LINCOLN CITY/LANCASTER COUNTY PLANNING STAFF REPORT

for June 23, 2004 PLANNING COMMISSION MEETING

P.A.S.: Special Permit #04025
Liberty Village CUP

PROPOSAL: 16-unit, single-family detached residential development with
waivers.

SITE PLAN

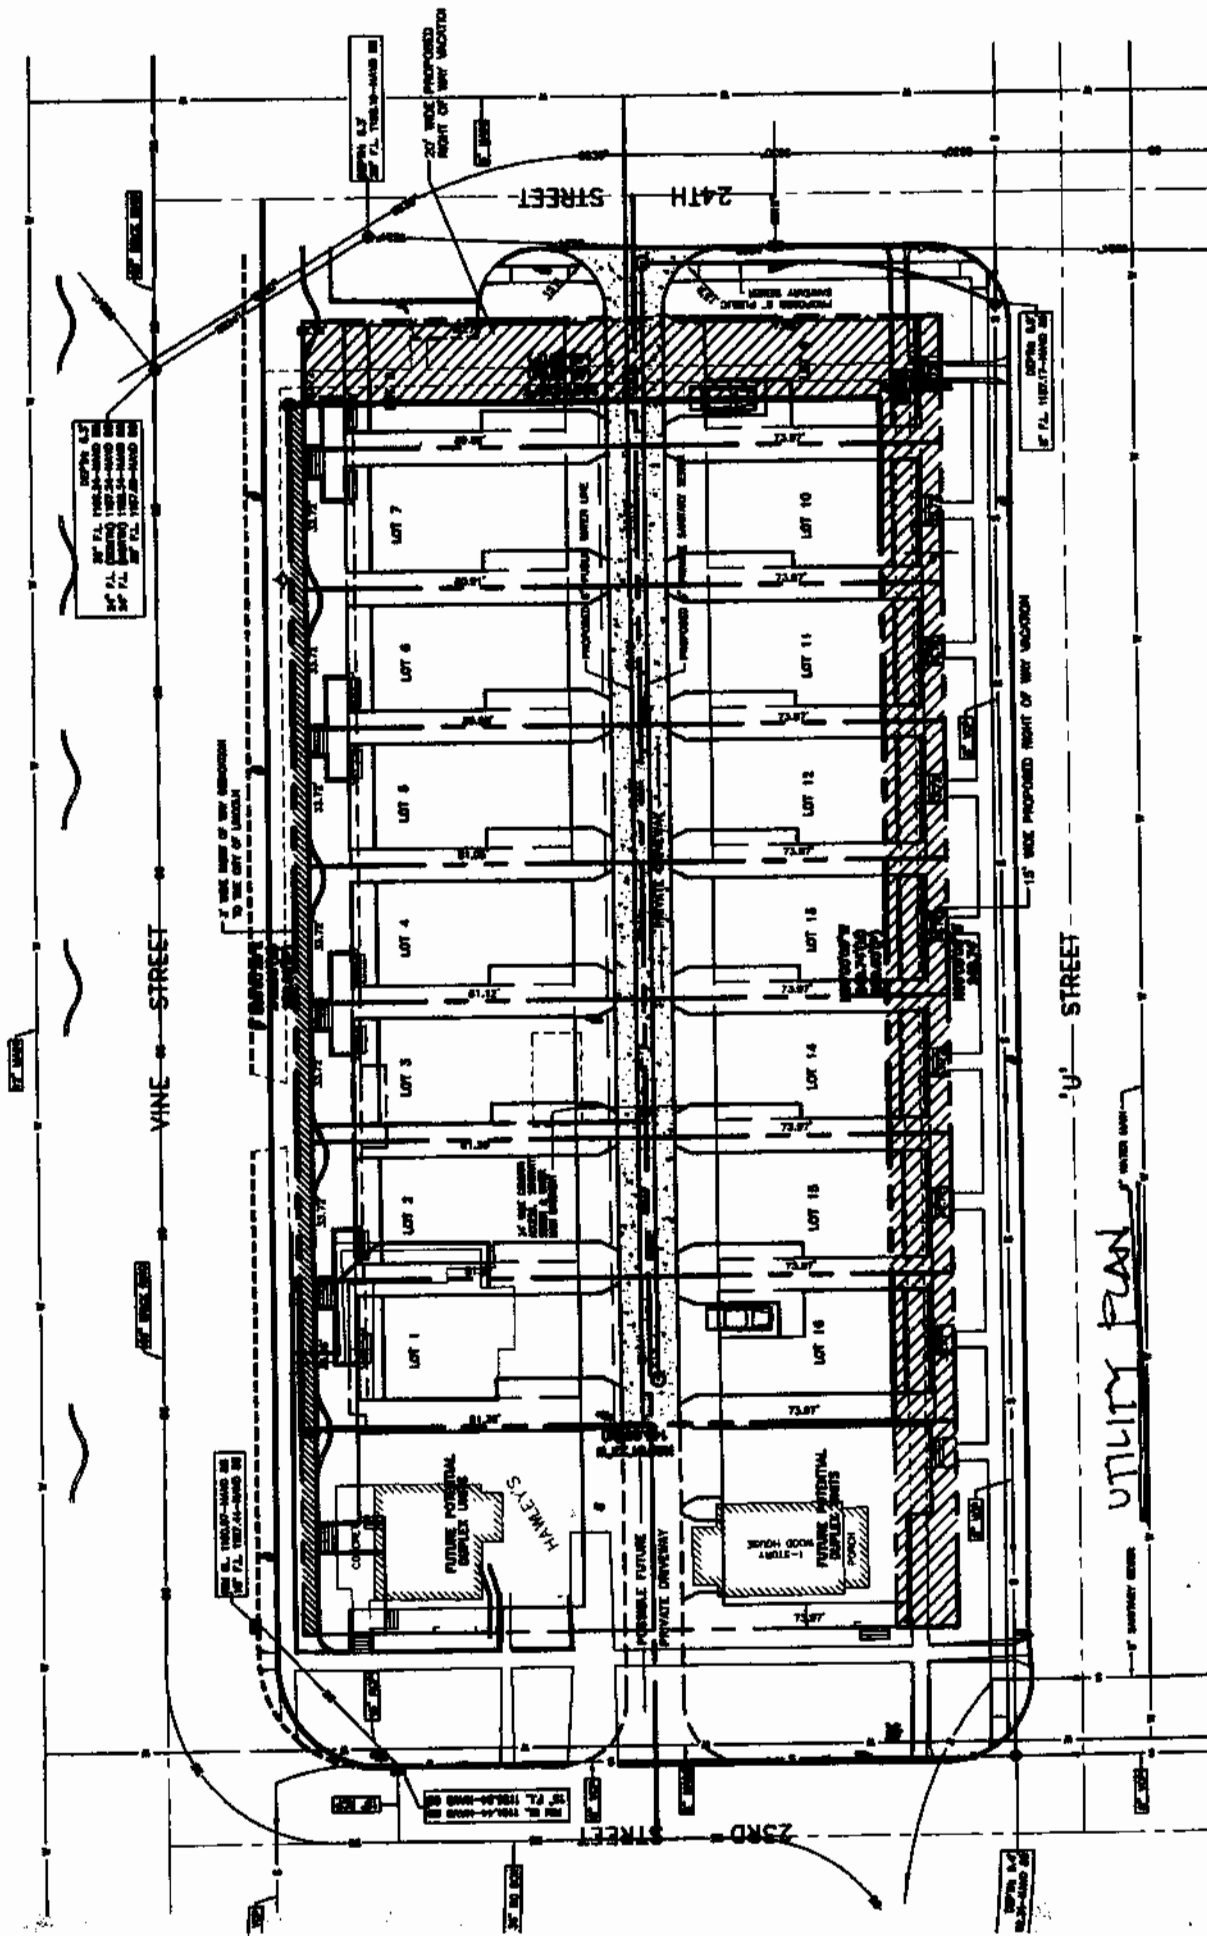
UTILITIES: Applicant's letter states utilities will be public, however, the drawings indicate sanitary sewer will be private. In either case, the depth of the sanitary sewer will not allow the basements proposed for some units. If the sewer is private, it cannot be constructed within the required 30' water main easement. If the sewer is to be public, a shared 40' easement is required for the water and sewer mains together. Site limitations may require additional waivers not yet requested.

The proposed grading plan does not match existing grades on the west end creating drainage problems for the westernmost units. Also, the profile for the driveway creates a low point at the western end, but provides no outlet for storm drainage.

6. The front yard setback waiver changes the front yard setback from 20 feet to 5 feet along "U" Street, 10 feet along Vine Street, and 1 foot along 24th Street. However, the site plan indicates there will still be approximately 20 feet between the dwellings and the curb line along "U" and Vine Streets, and 15 feet along 24th Street. The standard separation between the dwelling and curb line in R-6 is 42 feet, including a 25 foot front yard setback and 17 feet of right-of-way for sidewalk, utilities, and street trees.

7. The side yard setback is changed from 5 feet to 4 feet in most cases, with the westernmost units having a 7 foot setback in the west side yard. The zoning ordinance allows eaves to project 2 feet into a side yard, resulting in eaves only 4 feet apart. This separation still appears to meet building code requirements.

8. The rear yard setback is measured to the center of the driveway, and is shown as 17 feet, which exceeds the required setback of 14.8 feet. Although this would appear to offer some flexibility for increased front yards by decreasing the rear yard, the garages are only 10 feet off of the driveway, and the driveway is 14 feet wide. Reducing the rear yards to gain additional front yard setback would further congest the driveway area, and impact the easements for water and sewer.

17. Applicant’s submittal indicates some units will have full basements while others will not. However, the depth of the sanitary sewer will not allow basements for any units, unless injector pumps are used.

18. The Public Works Department states a private sanitary sewer line must be located outside of the 30' public water main easement. However, if the sewer is public, it may be located within a shared 40' sewer and water easement, with 10' between the sewer and water mains, and 15' between each utility line and proposed structures. The solution to these concerns may include additional waivers that will need to be advertised.

19. The Public Works Department notes there must be 15 feet of separation between the water main and any structure, or the water main must be installed in an encasement pipe approved by the Water Department.

20. The proposed grading does not appear to match the existing grades on the west boundary of the development. The proposed grades are shown to be approximately two feet lower than the existing grades, which will cause drainage problems for the westernmost units. Also, the proposed profile for the main driveway shows a low point at the western end with no outlet for storm drainage. The grading needs to be revised to match existing grades and provide adequate storm drainage for the development. One option would be to obtain an off-site drainage easement across the property to the west and drain storm water to 23rd Street.

21. The Public Works Department points out the private driveway off of 24th Street is not a public alley. Therefore, maintenance and snow removal costs will be the responsibility of the developer or a homeowner's association. Also, since the driveway does not connect to 23rd Street at this time, trash collection, snow removal, moving and other maintenance type vehicles must back out the entire length of the driveway. Again, an option may be to obtain an off-site easement for a turnaround across the property to the west.

22. The 3' right-of-way dedication along Vine Street does not appear to be accurate. The approved street project shows 40' right-of-way from the Vine Street centerline, which would equate to approximately 3.5' to 4.5' of dedication along this block. The plans should be revised to show the correct right-of-way dedication.

23. A sidewalk connection from 24th Street to Vine Street must be shown on the site plan. The grading plan also needs to be revised to show the sidewalk connection. Also, the relocated sidewalks in "U" Street and 24th Street must be shown in the standard location of 3' from the new property line after the proposed right-of-way vacations.

24. Due to the proposed setback waivers, Lot 9 as proposed does not meet intersection sight distance requirements, and must be redesigned.
25. LES has requested easements.

1. After the applicant completes the following instructions and submits the documents and plans to the Planning Department office and the plans are found to be acceptable, the application will be scheduled on the City Council's agenda:
 - 1.1 Revise the site plan to:
 - 1.1.1 Show all requirements not waived.
 - 1.1.2 Show the correct right-of-way dedication along Vine Street.
 - 1.1.3 Show a sidewalk connection from “U” Street to Vine Street along 24th Street.
 - 1.1.4 Show all relocated sidewalks in the standard location of 3 feet from the property line.

- 1.1.5 Revise the setbacks on Lot 9 to conform to intersection sight distance requirements.
- 1.1.6 Show all required LES easements.
- 1.1.7 Add a note stating architectural design elements shall be substantially similar to those included in the Neighborhood Design Standards and the Liberty Village project proposal. Such architectural design elements may be changed through an administrative amendment approved by the Planning Director.

- 1.2 Revise the utility plan to:
 - 1.2.1 Clarify if the sanitary sewer will be public or private.
 - 1.2.2 If the sanitary sewer is private, show a 30 foot easement for the public water main, and show the private sanitary sewer located outside of the water main easement.

- 1.2.3 If the sanitary sewer is public, show a shared 40 foot easement for the public water main and public sanitary sewer main.
 - 1.2.4 Show the public water main is located a minimum of 15 feet from any structure, or is installed in an encasement pipe approved by the Water Department.

- 1.3 Revise the grading plan to:
 - 1.3.1 Match existing grades on the west boundary of the development.
 - 1.3.2 Revise the profile for the main driveway aisle to provide adequate storm drainage for the development.
